NOTICE OF VIOLATION

On August 8, 2024, Energy Safety conducted an inspection of SCE's WMP initiatives in the vicinity of the city of Lake Isabella, California. The inspection report is enclosed herewith. Energy Safety found the following violation(s):

INSPECTION REPORT

Item1G1mg1: Overall Pole

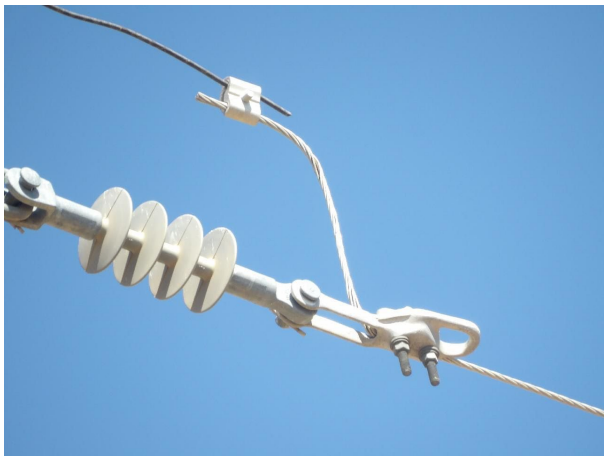
On Pole ID 4583938E, Grid Hardening ID TD1827254-4583938E, near the Auxiliary Dam Campground at Lake Isabella, CA, 35.644931, -118.460862, the inspector observed bare conductor where covered conductor was reported as installed. Pole ID 4583938E was inside the Auxiliary Dam Campground. The inspector's observation is documented in Violation 1 photographs, which are attachments to this report. Photo numbers Item1GImg1, Item1GImg2, Item1IA1Img1, and Item1IA1Img2 depict that no covered conductor was installed at the location.

1. Southern California Edison Company's 2023 WMP Covered Conductor (8.1.2.1.1) work was identified as complete at this location.
2. Covered conductor was not installed.
